# Belamy Textiles Ltd. Golden Son Ltd

Khowaz Nagar, Azimpura, Karnafuli, Chittagong  
18 MARCH 2014

# Executive Summary (Continued)

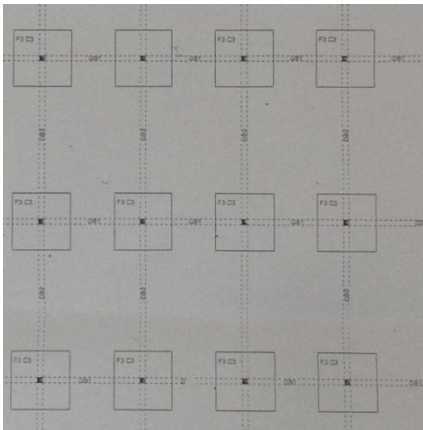
1. **All loads, including equipment, garments and personnel, in the area highlighted on the following page for all suspended levels are to be removed pending verification of column capacity by the Building Engineer.**
2. **All loads generally to be limited to 1.5 kN/m<sup>2</sup> pending verification of column capacity by the Building Engineer.**
3. **Detail Engineering Assessment** of the as-constructed Building is requested and this should be commenced immediately to the requirements of the scope attached and addressing the concerns as noted.

# Vertical Extension

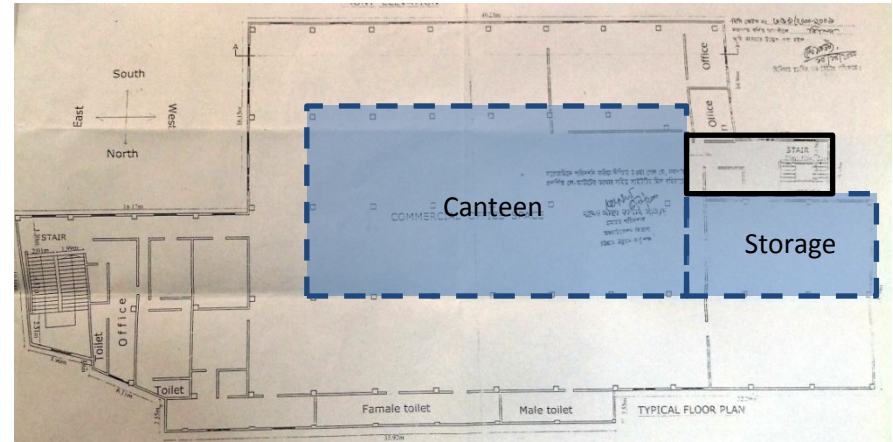
**Vertical extension on roof comprising lightweight steel trussed roof on concrete columns with brick masonry and glass infill.**

**No structural or design documentation provided for extensions.**

**Lightweight steel structure, not on permit plans, subject to wind uplift.**

**Adequacy of tie-downs and lateral stability need to be assessed by Building Engineer.**

**Check on roof additions required**

| Item No. | Observation                                                                                                         | Recommended Action Plan                                                                                                                                                             | Recommended Timeline |
|----------|---------------------------------------------------------------------------------------------------------------------|-------------------------------------------------------------------------------------------------------------------------------------------------------------------------------------|----------------------|
| 10       | Engineering Assessment of vertical extension for canteen on roof and additional loading from new adjoining building | Building engineer to verify structural design of additional structures.                                                                                                             | 6-weeks              |

# Localised areas of high loading

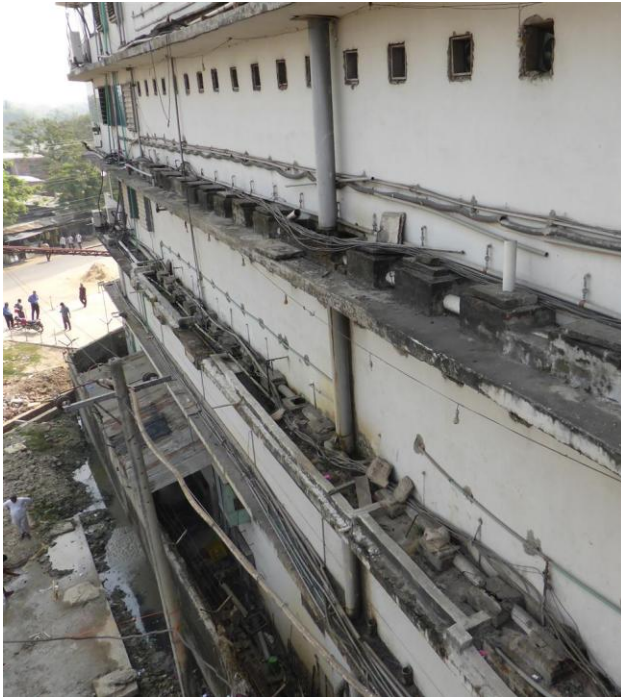
**Water tanks at roof level**

**Materials Store – 1<sup>st</sup> Floor**

**Areas of high loading on structure.**

| Item No. | Observation                                                                                                         | Recommended Action Plan                                                                                                                                                             | Recommended Timeline |
|----------|---------------------------------------------------------------------------------------------------------------------|-------------------------------------------------------------------------------------------------------------------------------------------------------------------------------------|----------------------|
| 13       | Localised areas of high loading                                                                                     | Reduce loading on areas highlighted for immediate action as per item 1                                                                                                              | Immediate - Now      |
| 14       | Localised areas of high loading                                                                                     | Create controlled loading plans for all floors, designating where storage can / cannot be placed, taking the findings of the DEA and of Item 1 into account                         | 6-weeks              |

## High loading at facade line along the toilet blocks

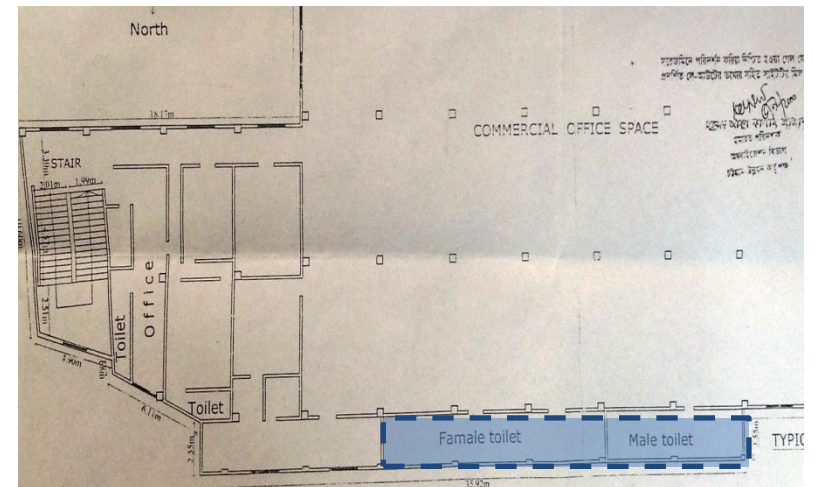
## Brick masonry facade walls with external drainage system on cantilever

## Increased floor build-up and partition loads in toilets

# Loading from neighbouring building

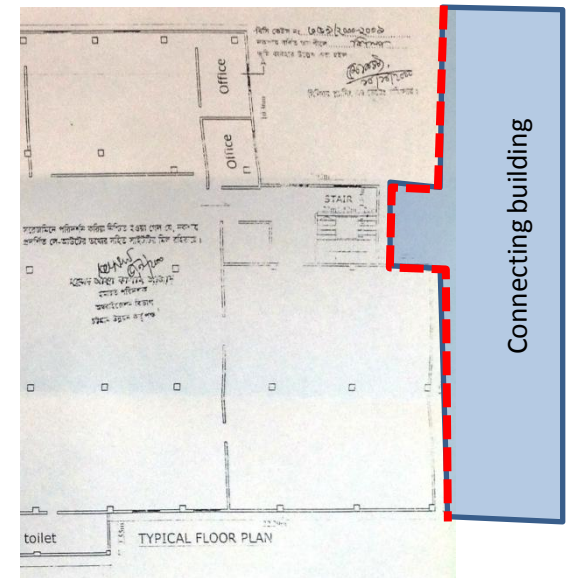
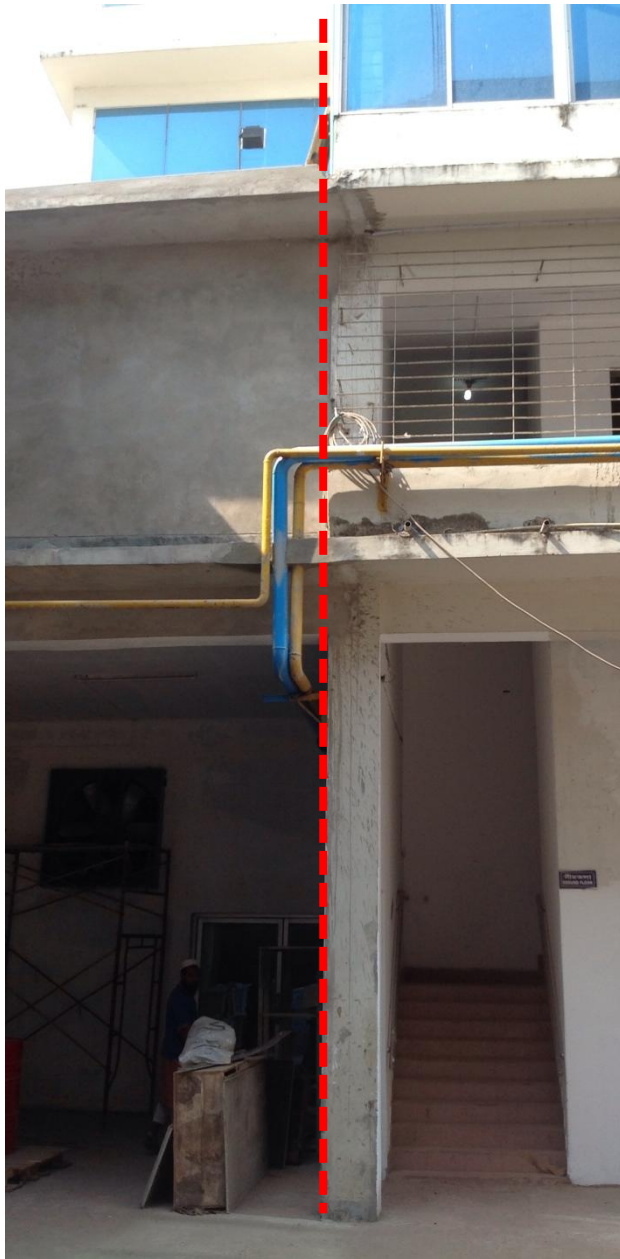
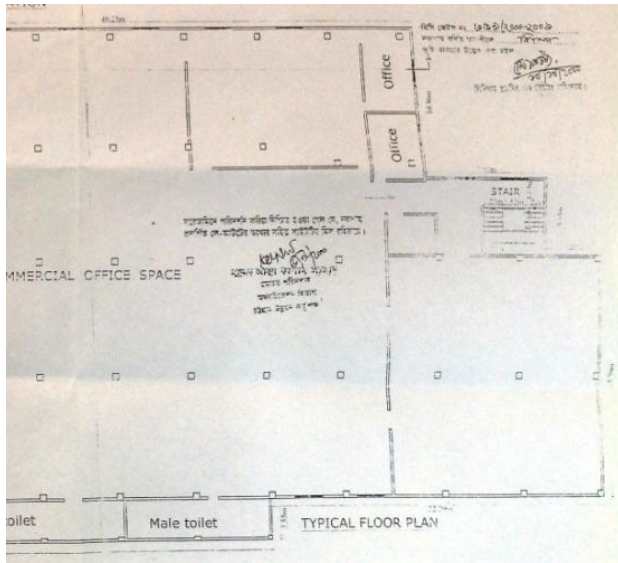
**No structural or design documentation provided for connected neighbouring building.**

**Shared columns between the extension and factory.**

| Item No. | Observation                                                                                                         | Recommended Action Plan                                                                                                                                                             | Recommended Timeline |
|----------|---------------------------------------------------------------------------------------------------------------------|-------------------------------------------------------------------------------------------------------------------------------------------------------------------------------------|----------------------|
| 11       | Engineering Assessment of vertical extension for canteen on roof and additional loading from new adjoining building | The Building Engineer should check the load plans and confirm that the main building structure is capable of safely supporting the additional structures, to ensure no over-loading | 6-weeks              |

# **Substantial differences between as-built structure and design drawings provided**

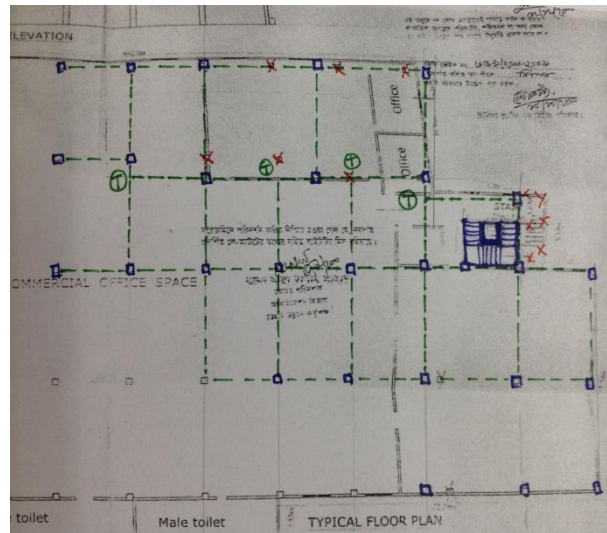
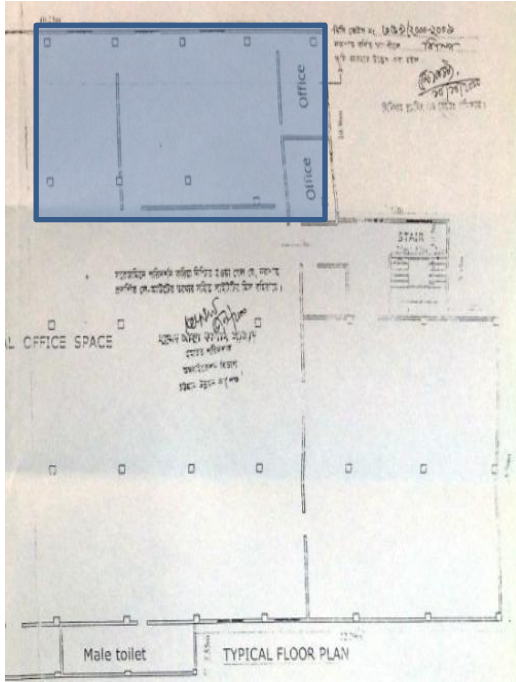
**Floor layout as per design documentation.**

**Observed floor layout**

**Design drawings are not consistent with the as-built structure.**

**Differences in column locations and beam arrangement.**

| Item No. | Observation                                                                                                                                             | Recommended Action Plan                                                                                                                  | Recommended Timeline   |
|----------|---------------------------------------------------------------------------------------------------------------------------------------------------------|------------------------------------------------------------------------------------------------------------------------------------------|------------------------|
| 18       | Modifications to building structure not reflected on the design documents (including double height space, gantry crane support & change of column size) | Slabs, Beams and supporting Columns that differ in load condition and span from original design to be assessed by the building engineer. | <b>6-weeks</b>         |
| 19       | Modifications to building structure not reflected on the design documents (including double height space, gantry crane support & change of column size) | Building engineer to check, collect information and produce accurate and complete as-built documentation                                 | <b>6-weeks</b>         |

## Inaccurate Building Documentation

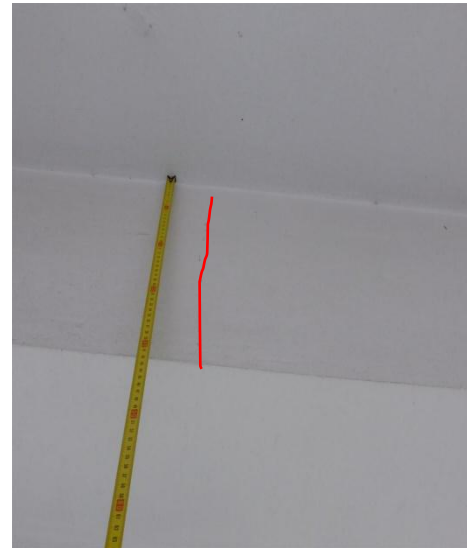
**Floor beam acts as structural beam to transfer the reaction from the orthogonal floor beam to the column positions in a number of locations.**

**Undocumented double-height space from ground level inconsistent with structural drawings.**

**Crane beams supported on column corbels in a number of locations on ground floor.**

# Cracking over structural elements

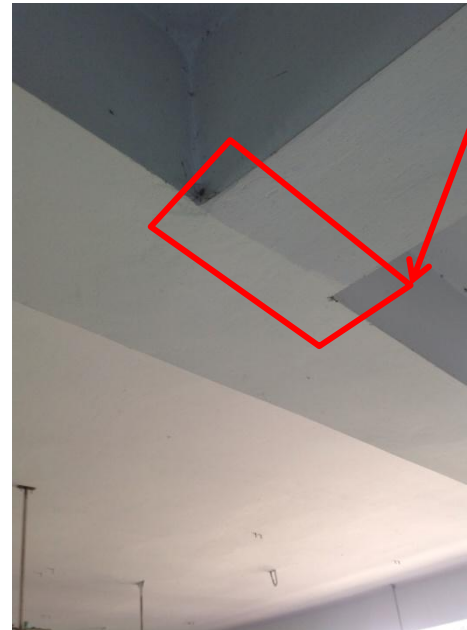
**Cracking on surface at a number of locations above long-spanning beams.**

**Cracks run parallel to beam span.**

**Vertical cracking on a number of beams.**

**Evidence that selected beams have been recently decorated at locations consistent with cracks observed.**

| Item No. | Observation                              | Recommended Action Plan                                                                                                                                     | Recommended Timeline |
|----------|------------------------------------------|-------------------------------------------------------------------------------------------------------------------------------------------------------------|----------------------|
| 22       | Cracking observed on structural elements | Sections of plaster finish and screeds to be removed to investigate if cracks penetrate into the building structure.                                        | 6-weeks              |
| 23       | Cracking observed on structural elements | Verify that beam/slab has sufficient capacity to support applied load and structural arrangements                                                           | 6-weeks              |
